Groundwater Remedy Phase 1 Construction, PG&E Topock Compressor Station, Needles, California

Work Variance Request #3 – Proposed changes within the Construction Headquarters (CHQ) fence line

Revised Drawings for Work Variance Request #3

Drawings from Approved Final Design (November 2015)

2 BURIED STORAGE TANK
NO SCALE
C-15-01

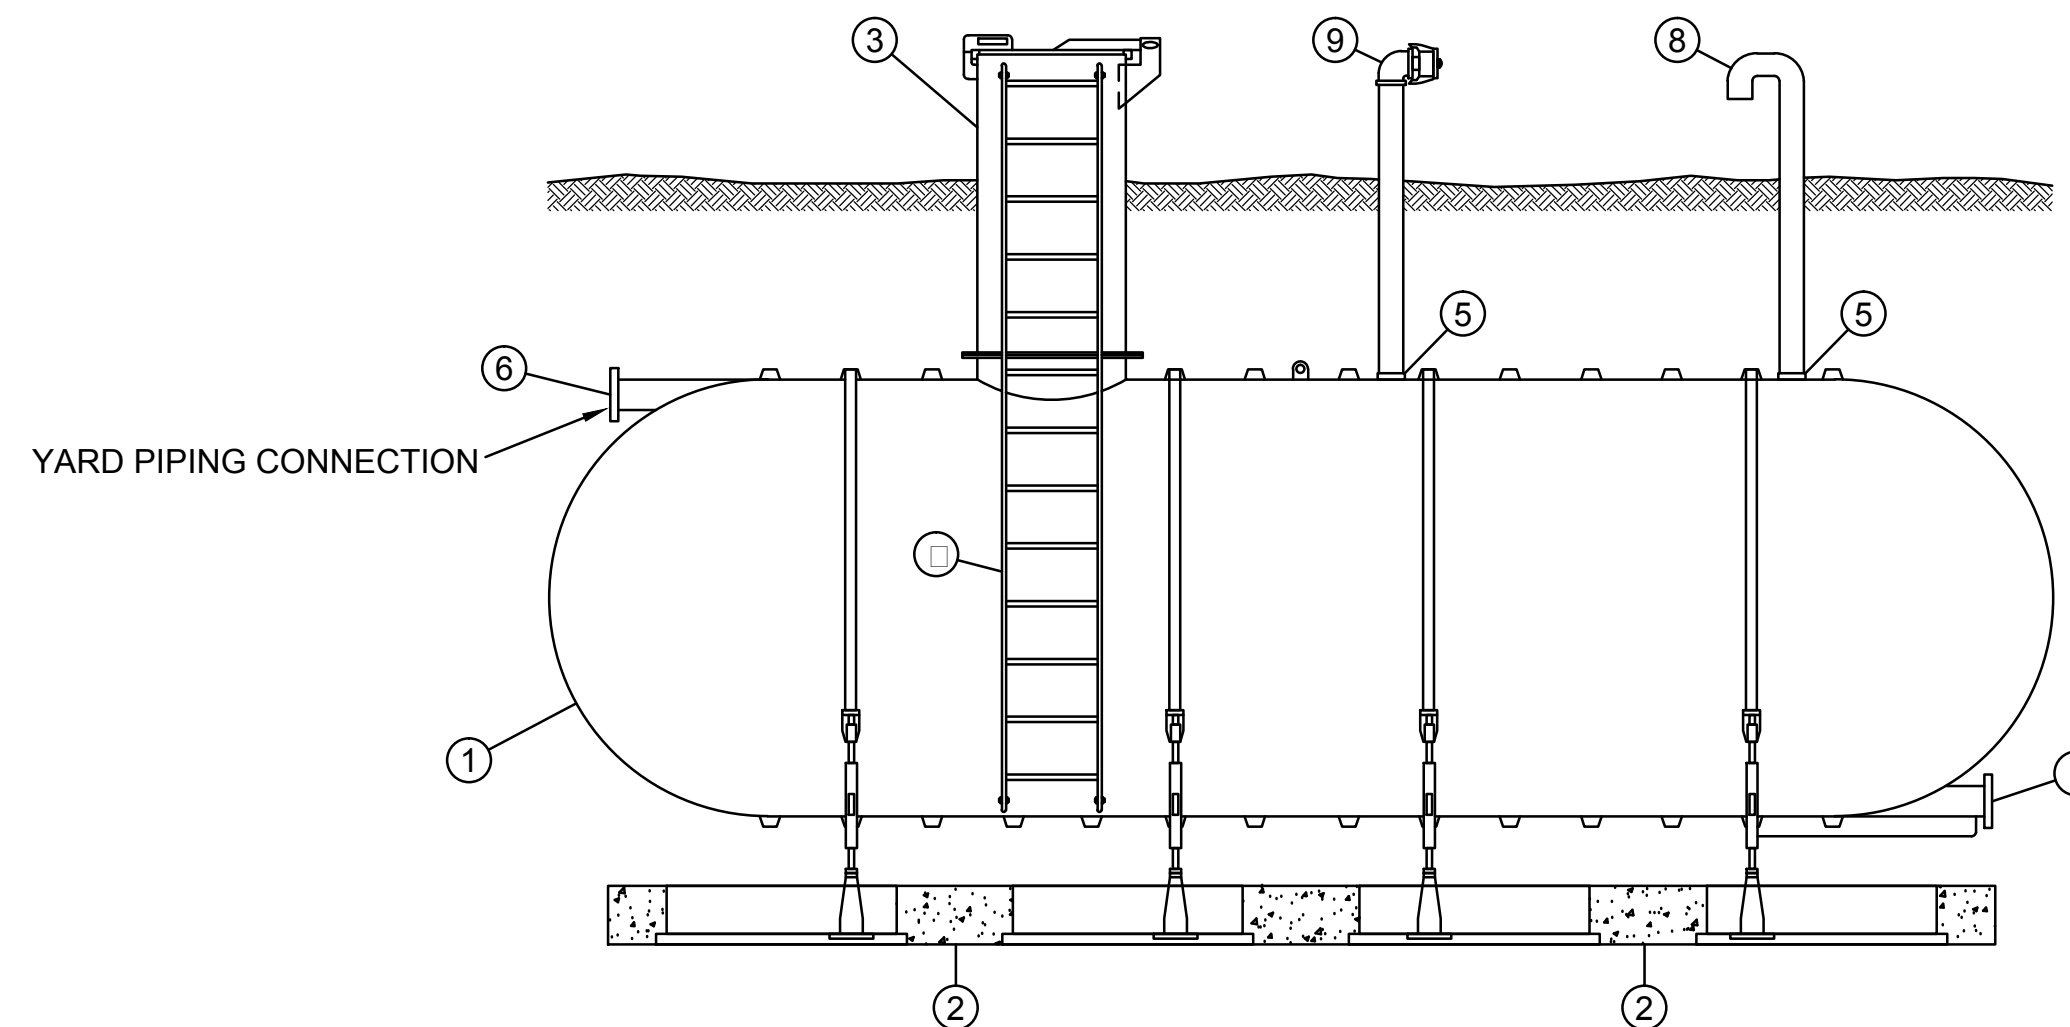
- b) **Bring the remedy-produced wastewater tank from belowground to aboveground, increase the tank volume from 1,000 to 2,500 gallons, and place the aboveground, double-walled tank adjacent to the decontamination pad.** The change from belowground to aboveground reduces the amount of soil disturbance by at least 50 cubic yards. The change to a bigger tank will reduce the amount of truck trips needed to haul wastewater. The placement of the tank adjacent to the decontamination pad allows for the pad to function as a secondary containment for the haul truck during off-loading of the wastewater.

- c) **Defer construction of the underground sewage tanks.** Deferral of the underground tanks reduces the overall amount of soil disturbance by at least 800 cubic yards. All sanitary wastes will be managed in aboveground sewage tanks (similar to the ones currently used for the SPY trailers) or portable toilets.
